LANDSCAPE & VISUAL IMPACT ASSESSMENT ADDENDUM

Hogshaw Farm
Buxton

1.0 LANDSCAPE CONSULTANT'S RESPONSE

Figure 1.1 - Local Constraints Plan

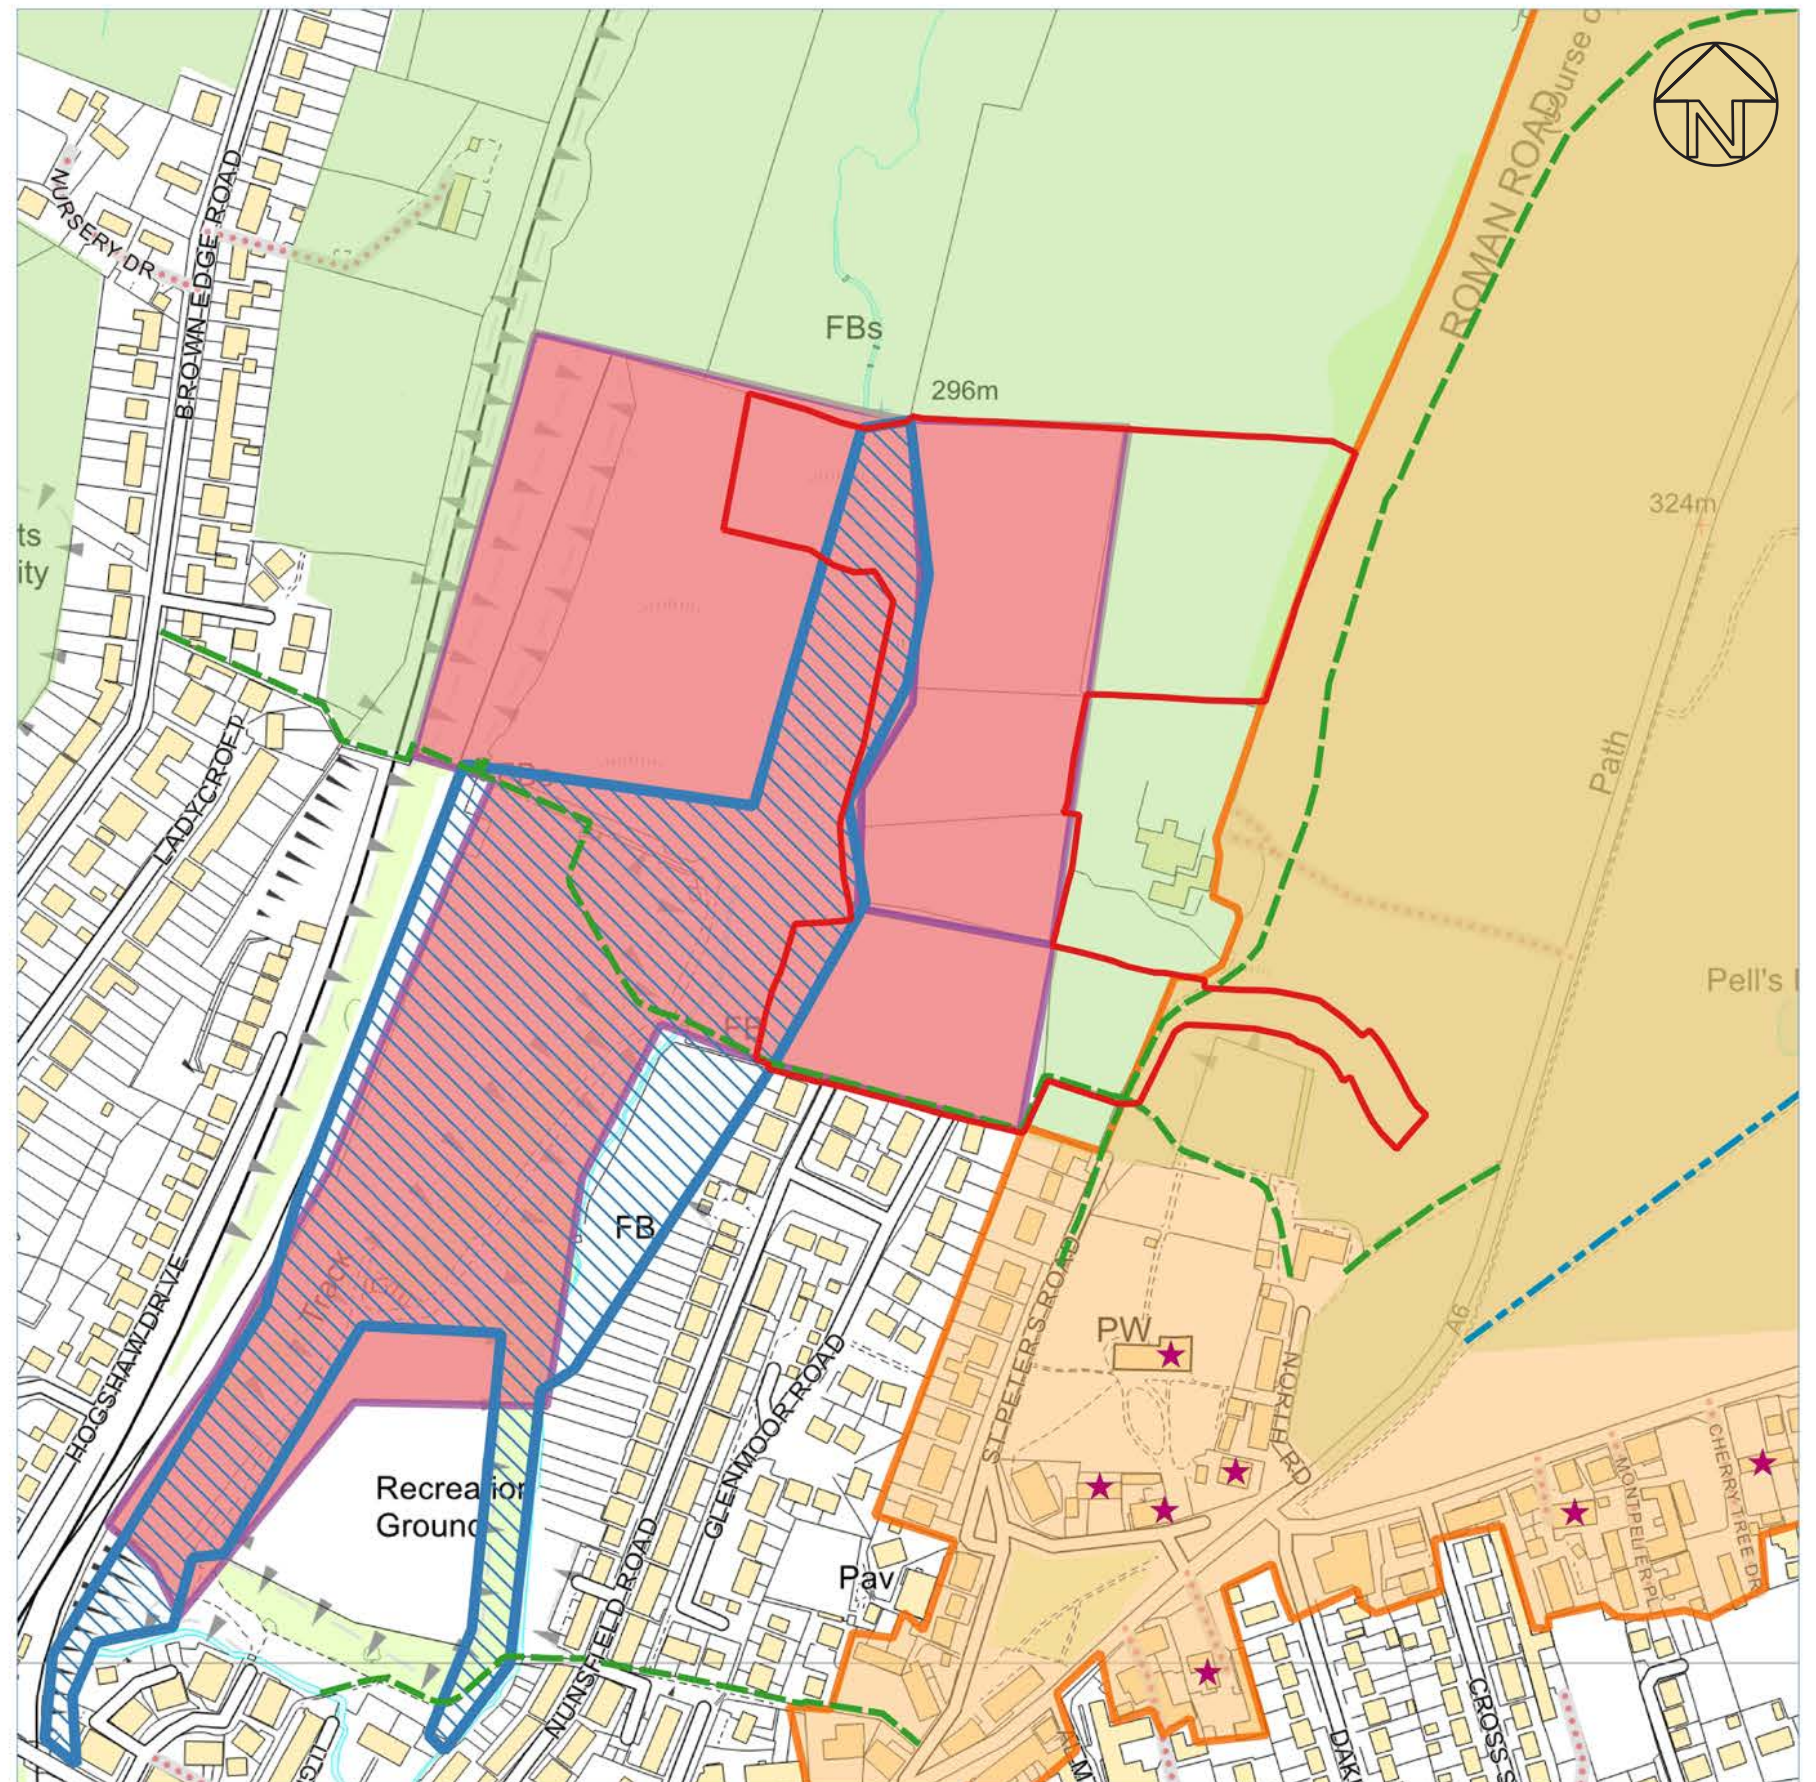
We respectfully dispute the assertion that the proposal extends the settlement boundary. The development aligns with the boundary of the Housing Site Allocations area, except for technical adjustments (e.g. the access road alignment and the north east field parcel) that do not constitute a material extension. The north eastern boundary adjustments are constrained by topography, the existing field pattern and existing green infrastructure lining the Site's eastern boundary and interface with Fairfield Conservation Area. This ensures coherence with the existing urban edge and will not extend development beyond the existing northern and eastern extremities associated with the developed edge of the town. Figure 1.1 Local Constraints Plan, illustrates the Site boundary in relation to the Housing Site Allocation - Land at Hogshaw Buxton (B3, B4), the Local Wildlife Site associated with Nun Brook within and to the west of the Site, the of Area of Countryside, Fairfield Conservation Area, the Listed Buildings and Public Rights of Way within the vicinity of the Site. Were the proposed development to extend further west into the Housing Site Allocation area, there would be anticipated to be a degree of impact on the Local Wildlife Site and the woodland within this area resulting in further tree loss and changes to the character of this portion of the allocation. The High Peak Local Plan supports proportionate infill development in this context, and the scheme adheres to its spatial strategy.
